41-43 Brigham Creek Road, Auckland

Ecological Effects Assessment for resource consent

41-43 Brigham Creek Road: Plan Change: information request regarding ecological effects

We refer to the further information request dated 18 February 2022 from Todd Elder, Policy Planner at Auckland Council regarding Council's further information request for proposed private plan at 41-43 Brigham Creek Road, Whenuapai.

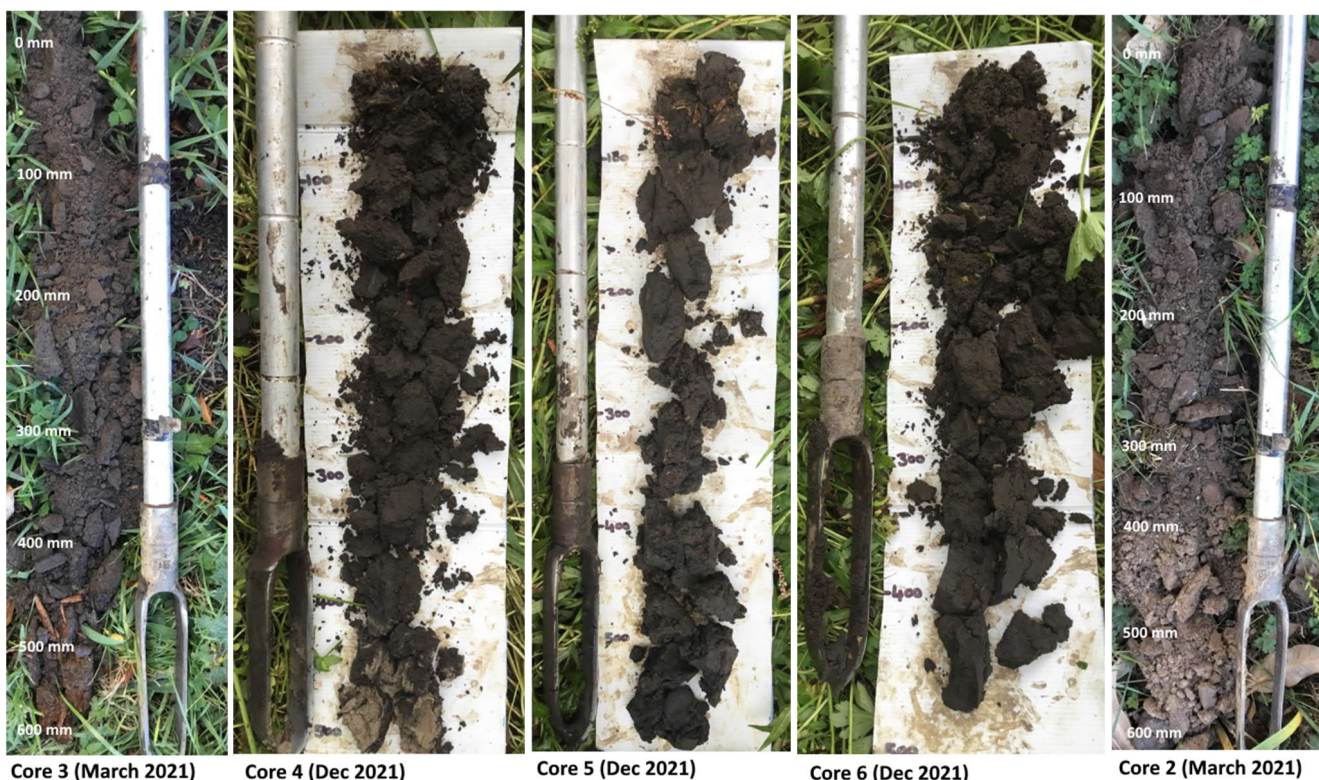
Our reply

The area referred to is an area where temporary ponding of water occurs. We agree that the vegetation (as dominated by non-pasture species of wetland facultative species) is an indicator of potential wetland status. However, the soils do not match (they are not hydric).

We re-visited the site on 21 December 2021 and undertook further work on soils and vegetation. The vegetation is confirmed to comprise species that are adapted to wet environments – with a dominance of creeping buttercup and water pepper.

The flow chart within the guidance attached to the NPS-FM provides a step-wise sequence of assessment using vegetation, soil and hydrology indicators. The process requires that soils are hydric for a potential wetland site to qualify. It is not enough to have vegetation (or hydrology) as the only wetland indicators. Without qualifying soils, the site is not a wetland.

We took three more soil cores within this wet area – within the lowest point and on the edges. All soil cores were within areas dominated by wet-adapted plants (buttercup/ water pepper/ Yorkshire fog grass). These are shown below, together with the soil core taken in March 2021 within the same area, and a reference sample taken on the slope/ dry soils nearby. None contain indicators of hydric soils as defined in Fraser et al. (soil guide referred to in the NPS-FM wetland classification and delineation guidance). Soils must qualify as hydric soils for a potential wetland area to be classed as wetland – if it does not pass the soils test, it is not a wetland (see flow chart in the NPS-FM wetland delineation and classification guidance). Updates to this guidance chart in subsequent clarification documents from MfE have no legal standing (they cannot replace the NPS-FM official guidance) and in any case they also require that soils AND hydrology tests be both met together for a site to be classified as a wetland.

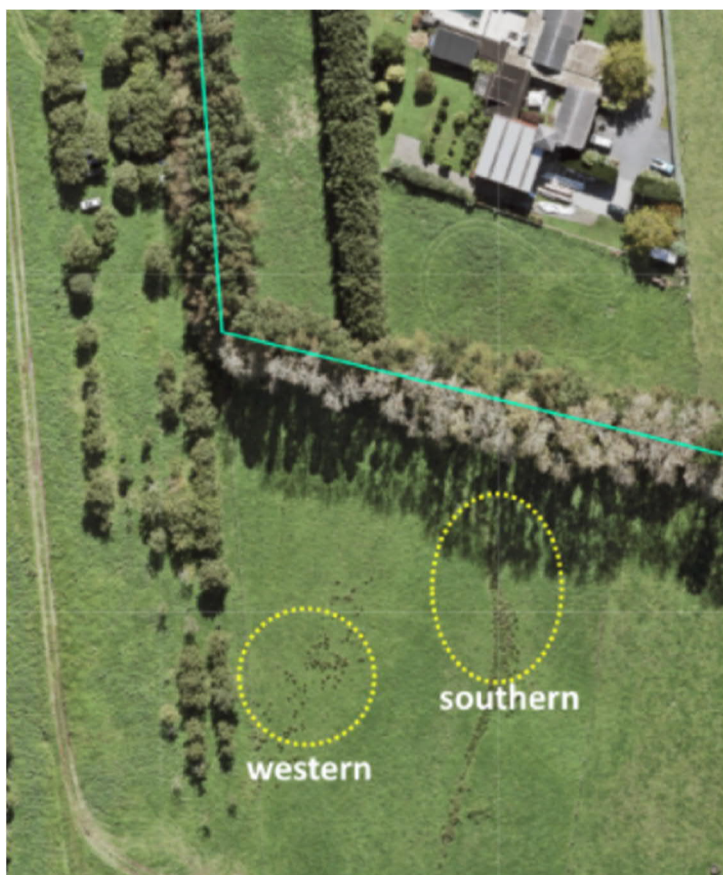
34. The Ecological Effects Assessment notes a potential natural wetland to the south of the subject site. From the site visit there would also appear to be an equally similar area approximately 30 metres to the west of the identified potential wetland.

Information request: Please comment and update assessment as necessary.

- Vegetation dominated by Yorkshire fog (55 %), lotus (5 %) and sweet vernal (5 %), with also creeping buttercup (10 %), soft rush (5 %), paspalum (10 %), sorrel (3 %) and bare ground (7 %).
- Soils are fine, moist, silts with light red mottling in the top 300 mm and a light low chroma colour change at 350 mm (see below). This qualifies this soil as a hydric (wetland) soil.
- Overall, while the area is wetter than the surrounding basin sides and spurs and the soils are hydric, the vegetation is dominated by pasture grass species (Yorkshire fog, lotus and sweet vernal; which are part of paddock maintenance (pasture improvement) including weed control, fertiliser application and re-seeding) – meaning that the site does not qualify as a natural inland wetland under the NPS-FM.
- The site does qualify as a wetland under the RMA.
